VILLAGE OF GERMANTOWN
N112 W17001 MEQUON ROAD, GERMANTOWN, WI 53022

MEETING:	PLAN COMMISSION
DATE AND TIME:	MONDAY, NOVEMBER 9, 2020 6:30 p.m.
LOCATION:	Germantown Village Hall Board Room N112 W17001 Mequon Road

11/9/20 Plan Commission Meeting

To : Jeffrey W. Retzlaff, AICP, Planning Director/Zoning Administrator
From : Lawrence Ratayczak, P.E., Director of Public Works
Date : November 3, 2020
Re : PAWS and Reflect Site Plan Review

CERTIFIED SURVEY MAP NO. _____

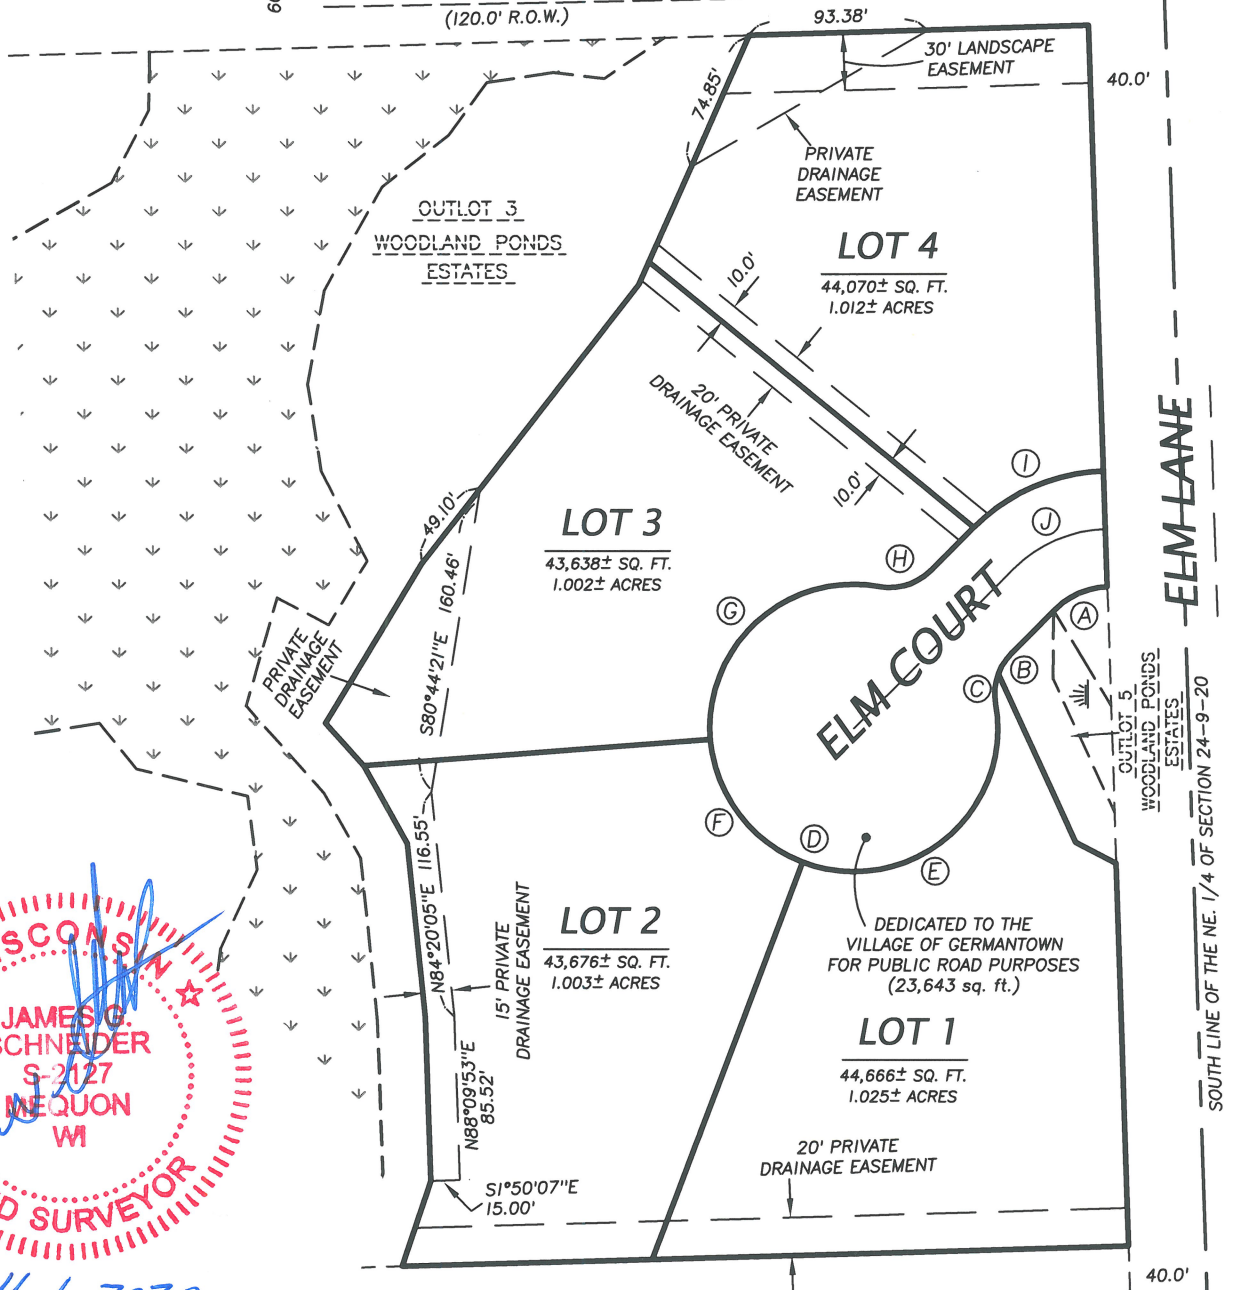
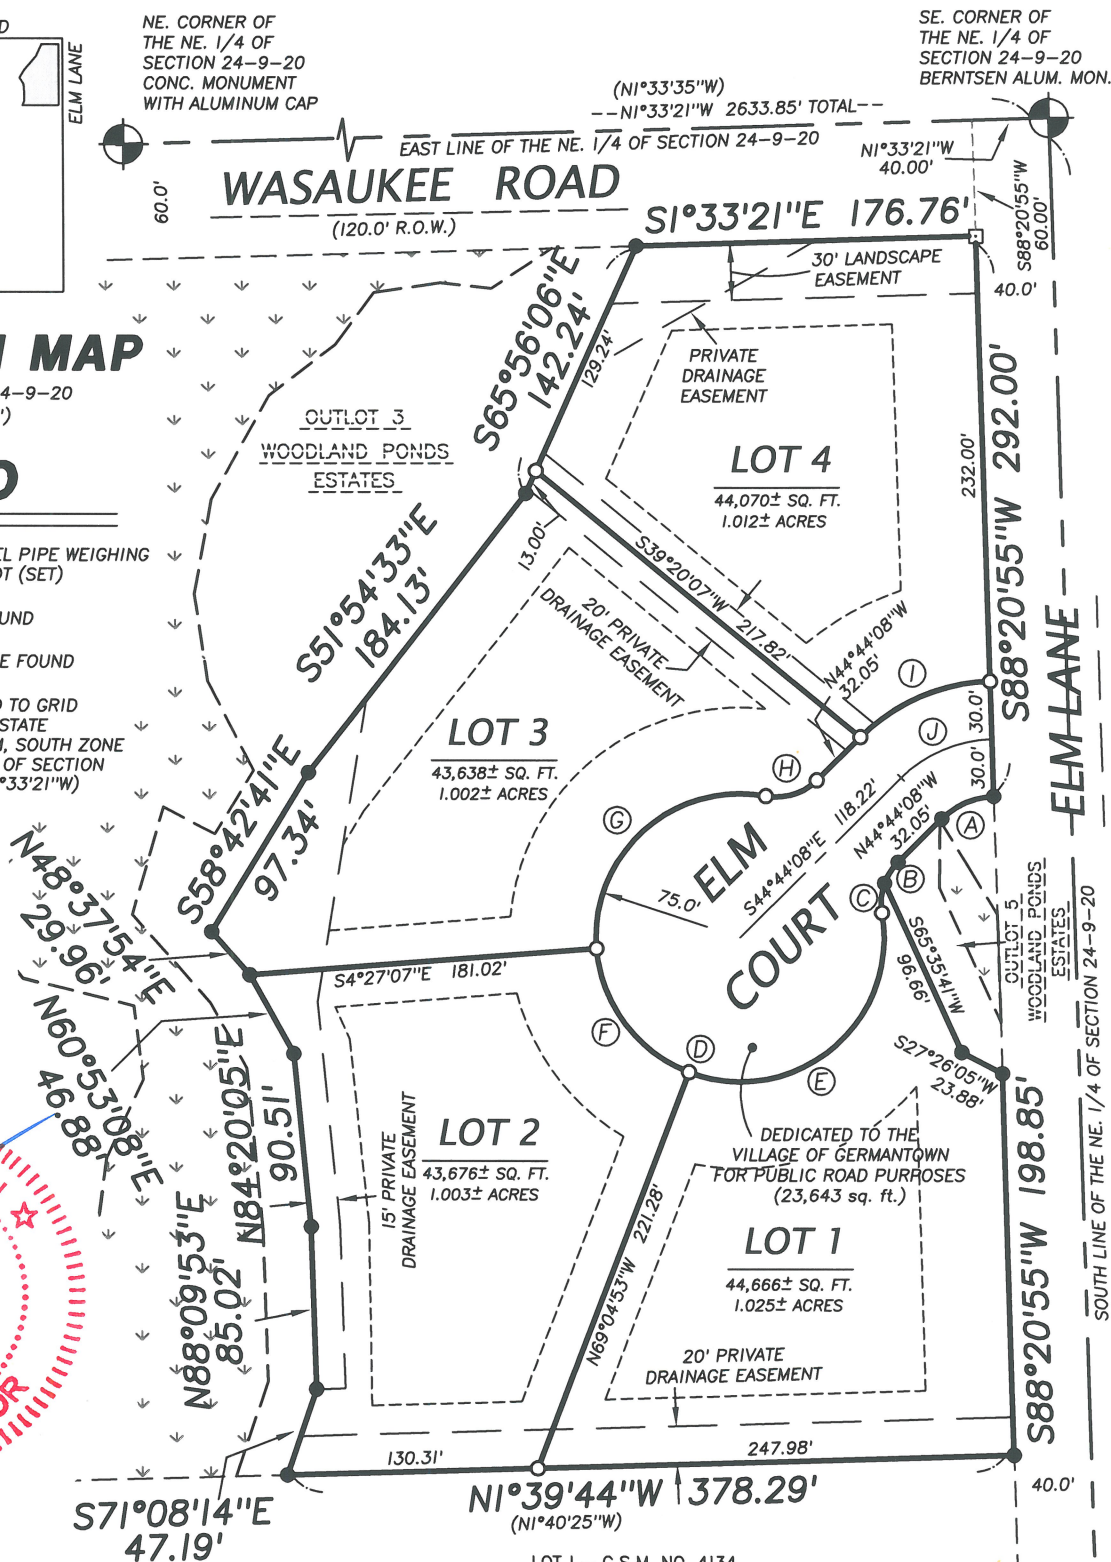
1. The bearing basis and horizontal datum should be NAD 83 (2011 Adjustment)
2. A 3"x 3" square in the upper right-hand corner of Sheet 1 is to be left blank for the County recording information. This reserved area is in addition to the areas needed for sheet borders. (per Washington County Register of Deeds Office)
3. Lot 1 and Lot 4 access to Elm Lane and Wasaukee Road is restricted. Please indicate the restriction by placing a ////////////// hatch along the road R/W's for both lots and a note indicating what the hatch depicts in the legend.
4. Please indicate the date of wetland delineation and who performed the delineation.

C-120 Site, Grading, and Demo Plan

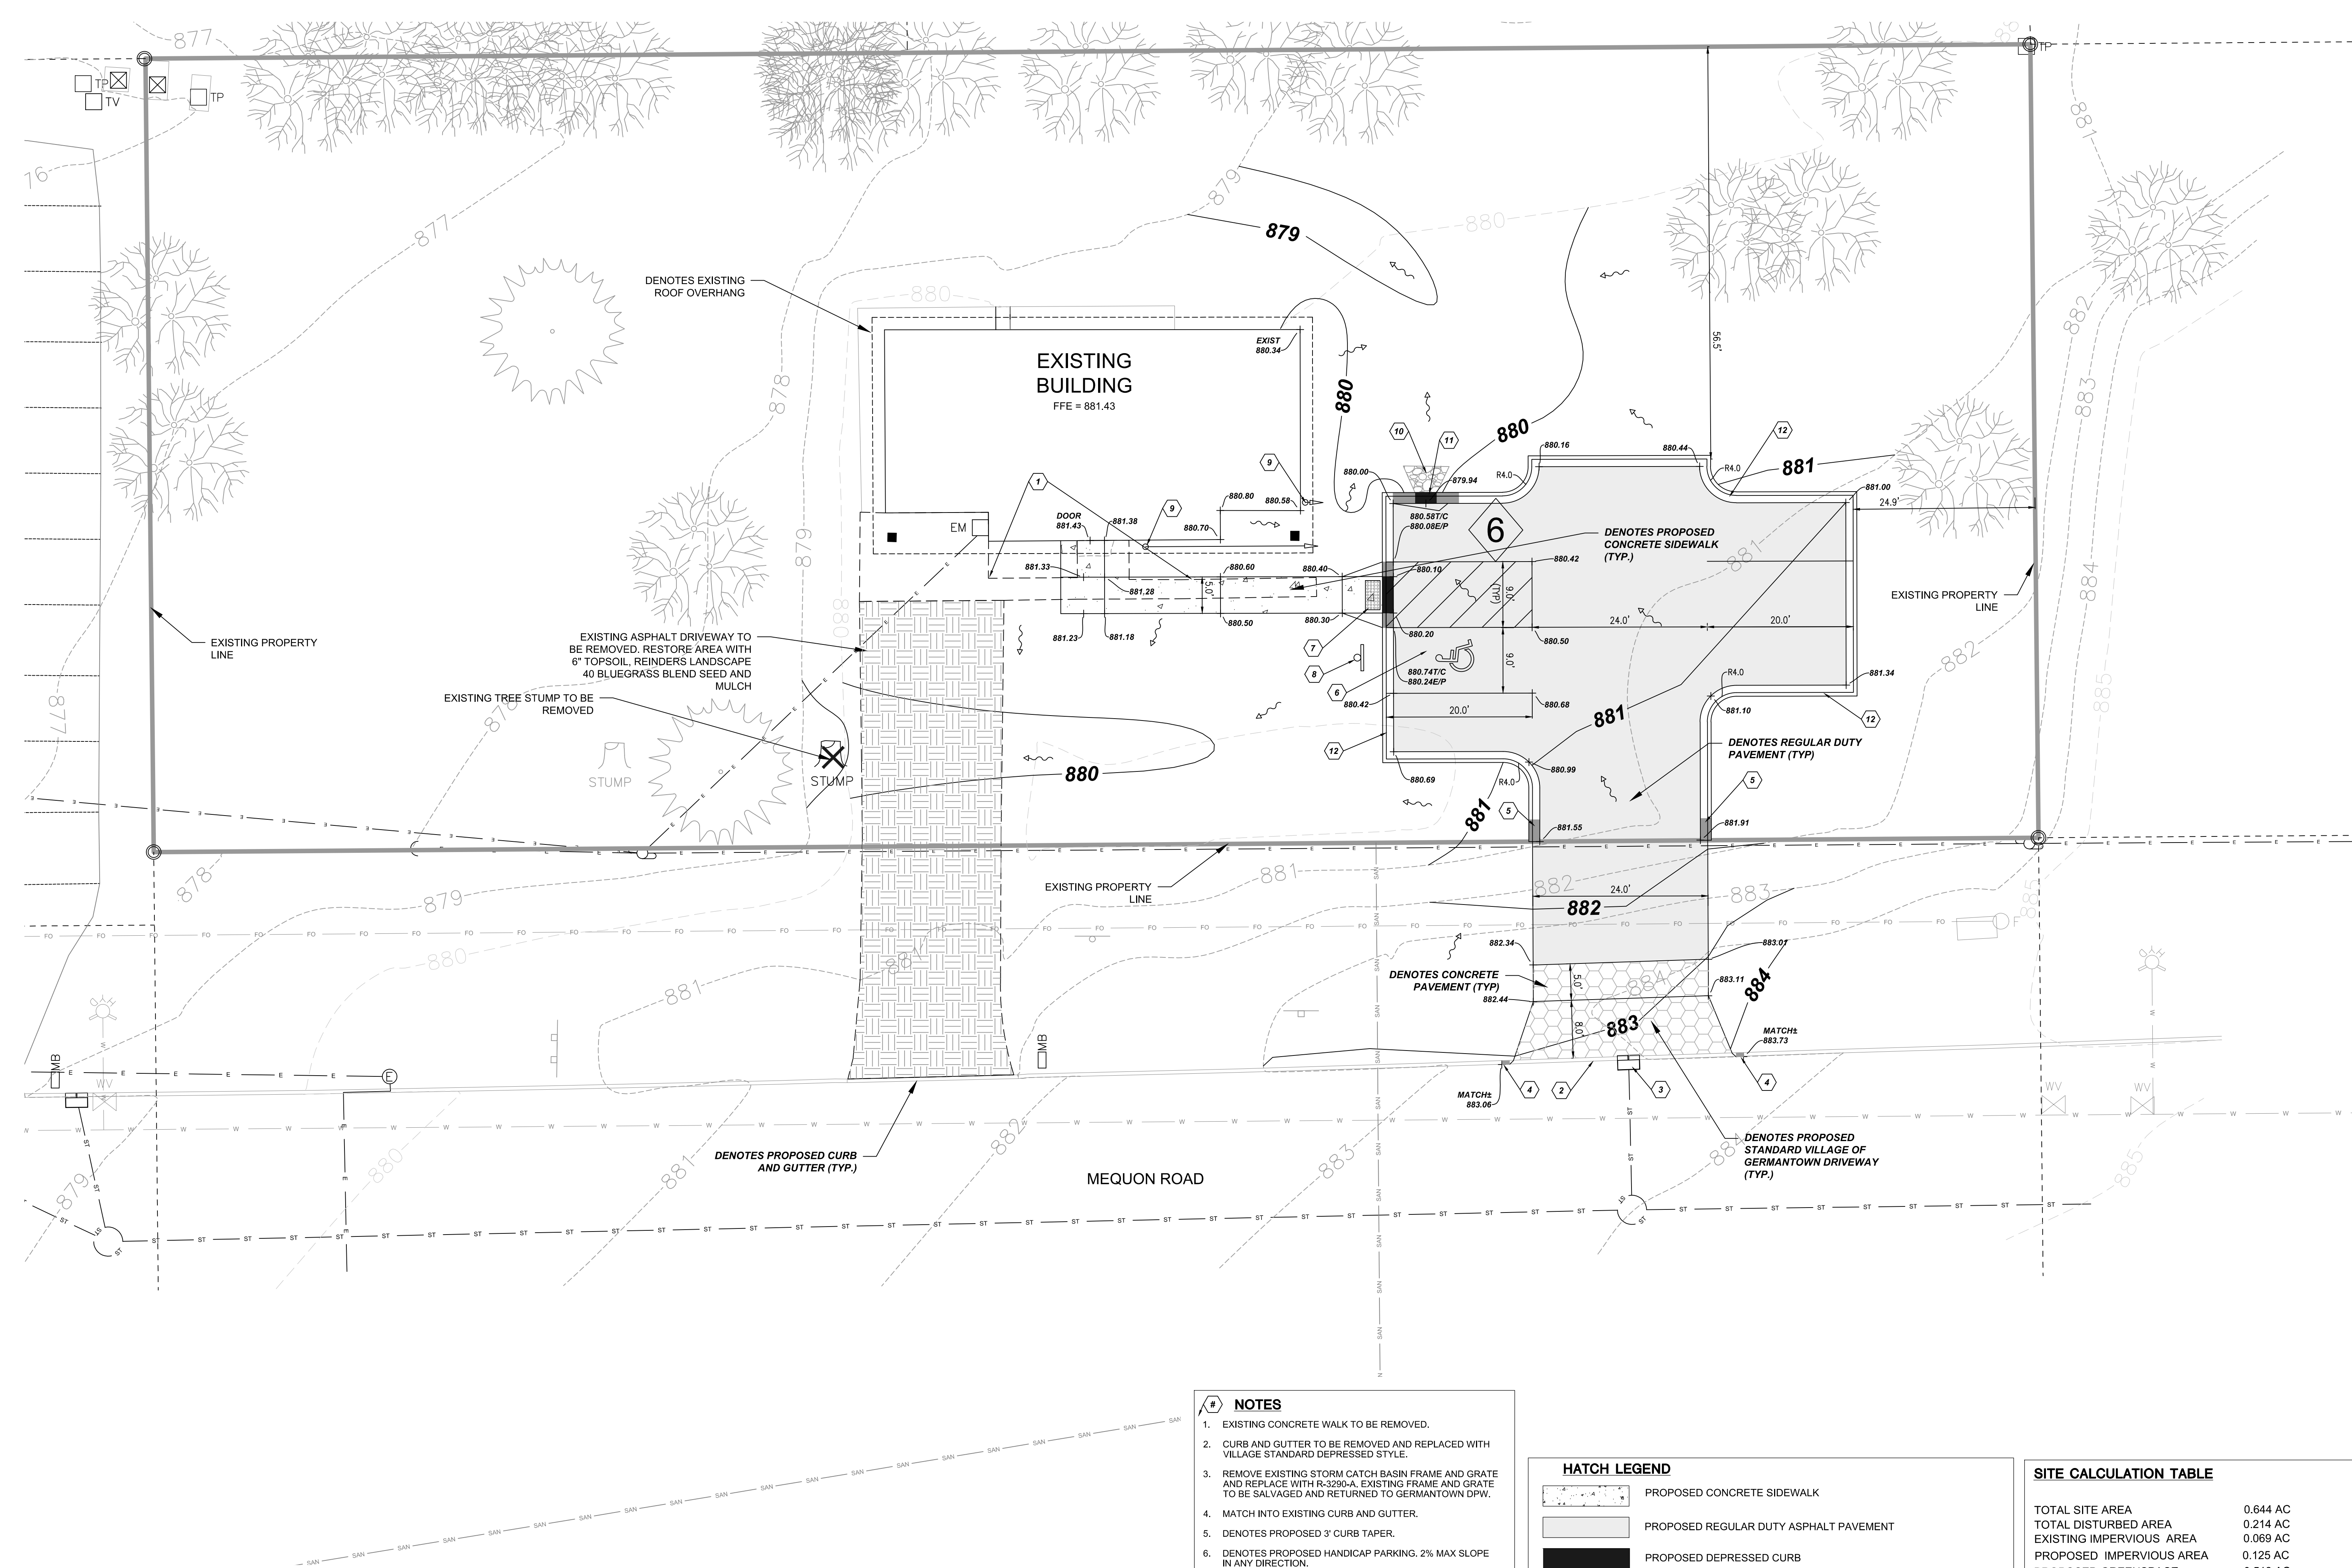
9. Add note on plan per 1.3.1.2 in Development Handbook, a note shall be prominently placed on each sheet of the Master Grading Plan indicating "The Village of Germantown shall not approve any grade change in excess of 0.25 feet unless authorized to do so by the Village Engineer."
10. Update driveway approach and concrete sidewalk to reflect Village standard driveway (i.e. sidewalk shall be 1 ft. off right-of-way).

C-130 Erosion Control Plan

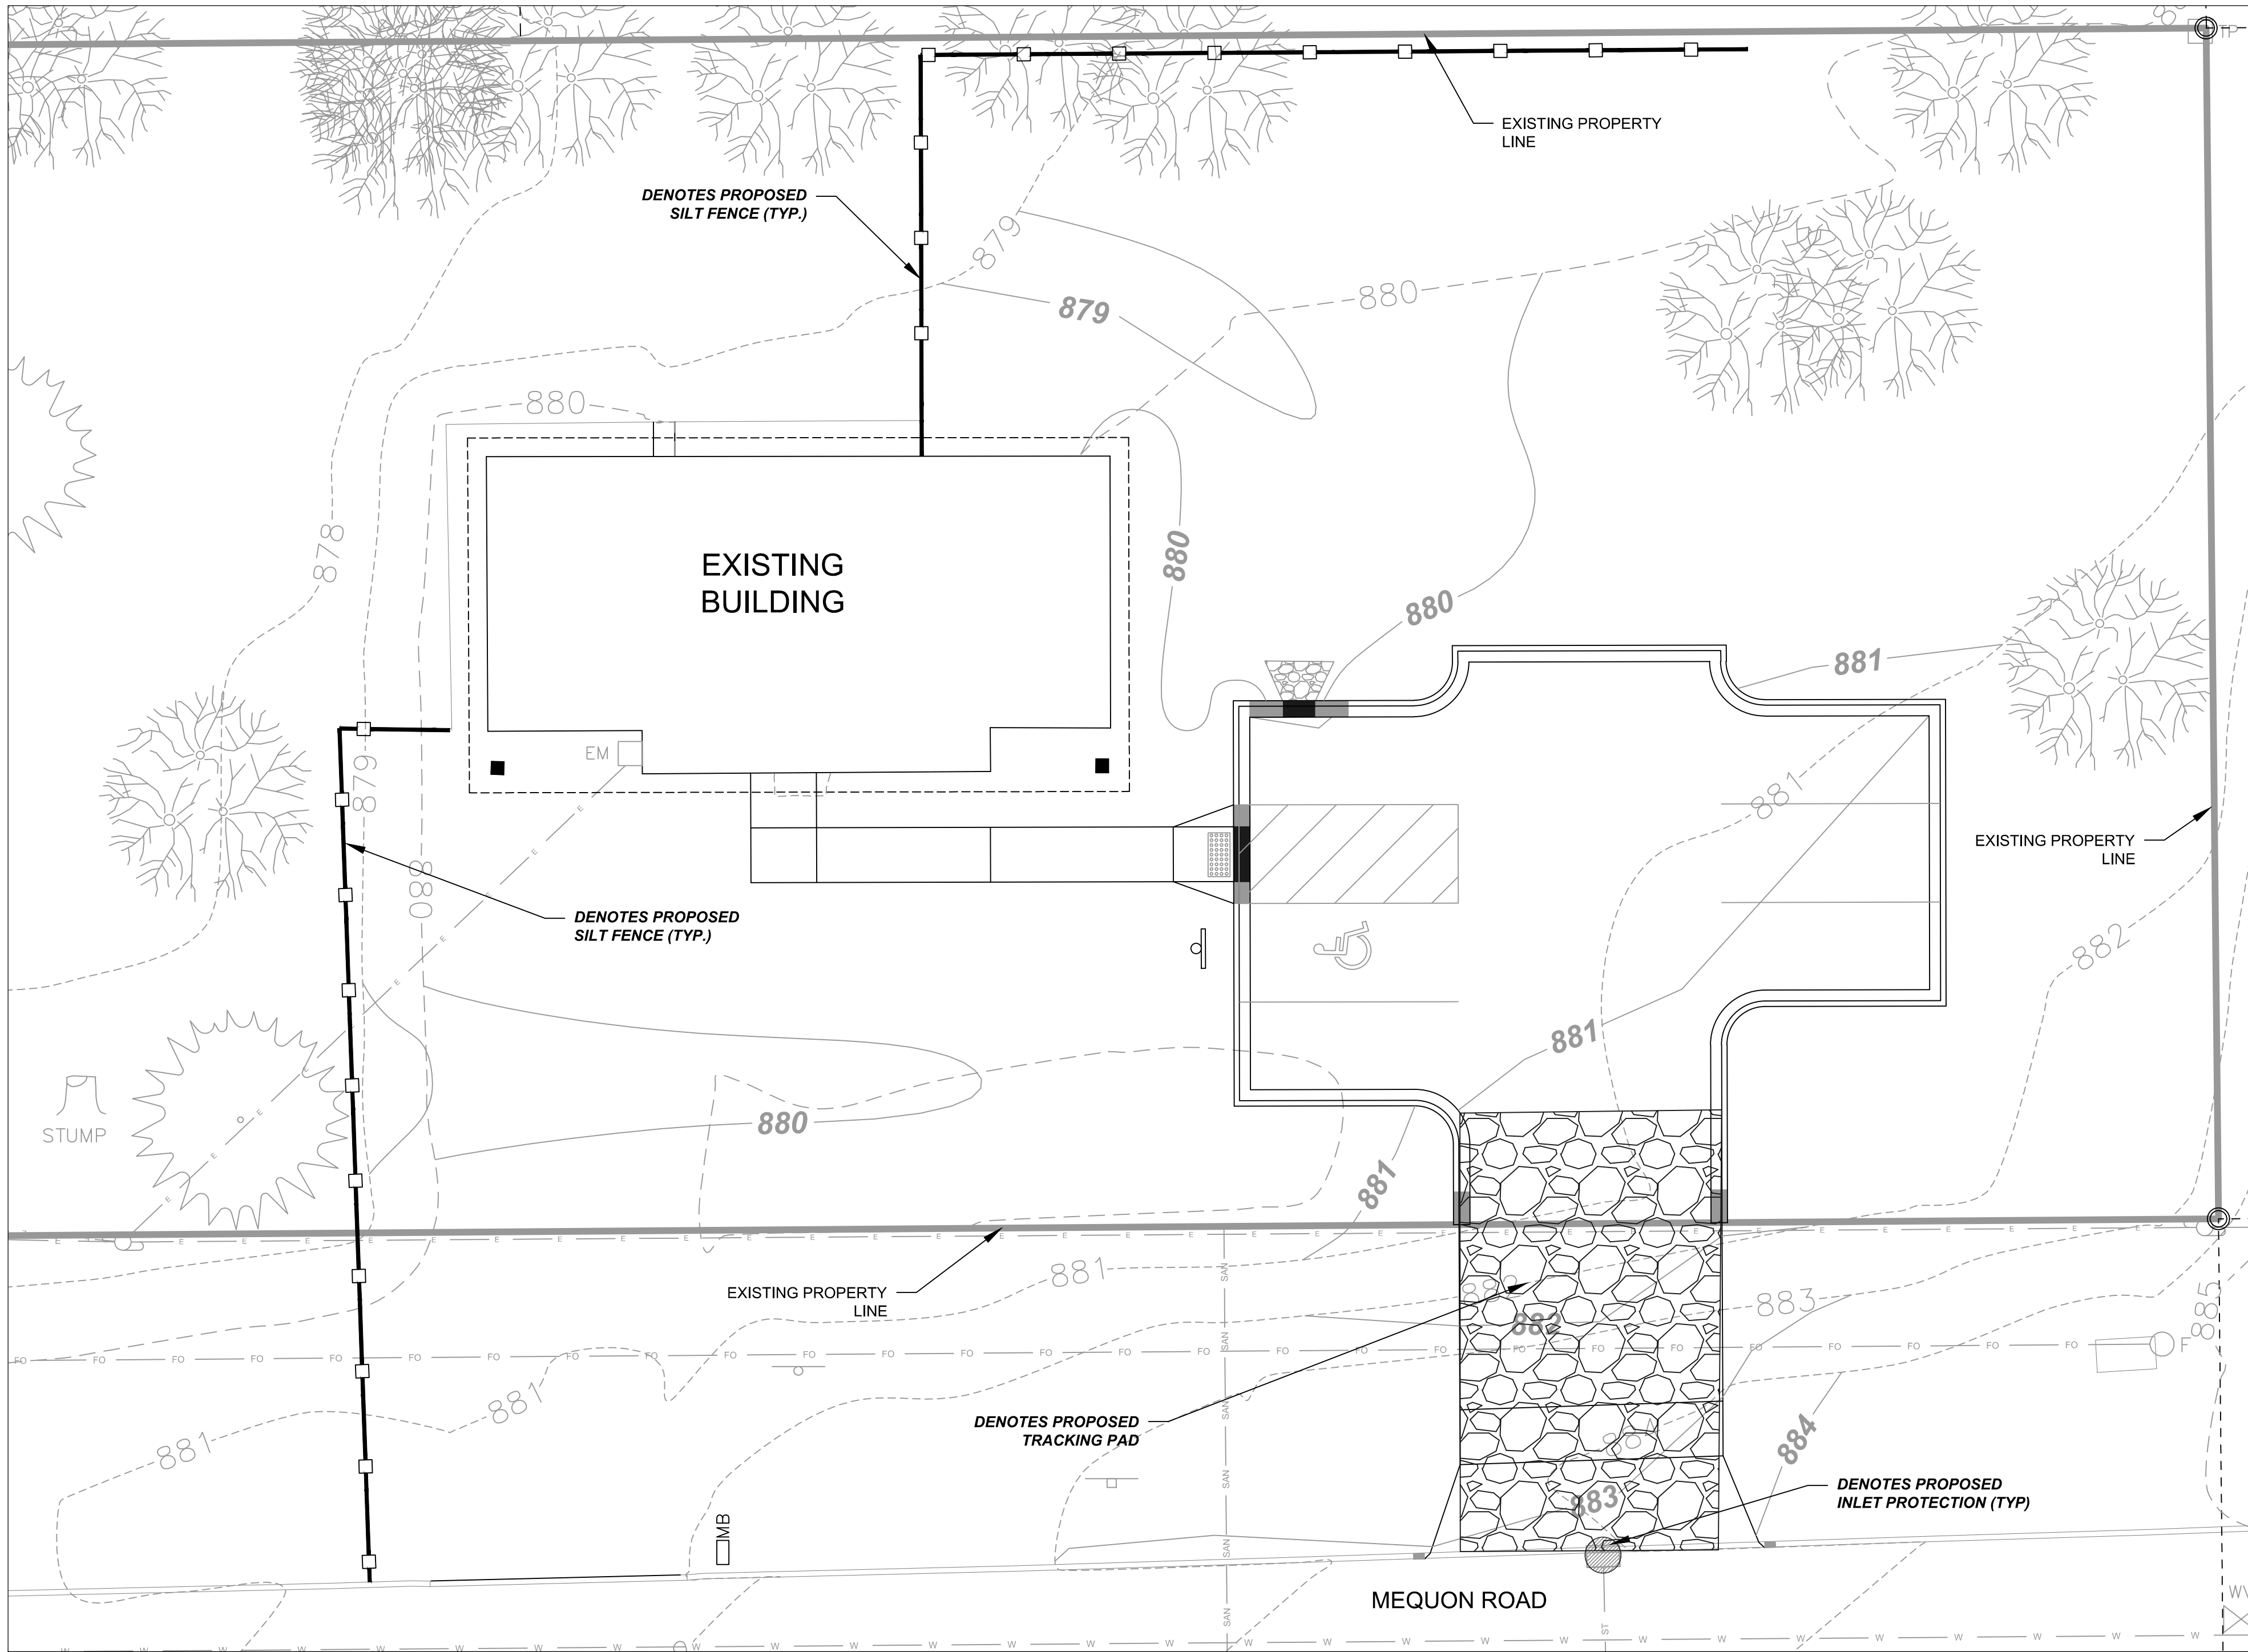
13. Please identify the type of restoration being placed on the existing driveway after pavement is removed per 1.4.6.5. "Areas to be sodded or seeded and mulched or otherwise, stabilized with vegetation, describing type of final vegetative cover."
14. Provide schedule of anticipated starting and completion date of each land disturbing and land developing activity including the installation of construction site control measures.
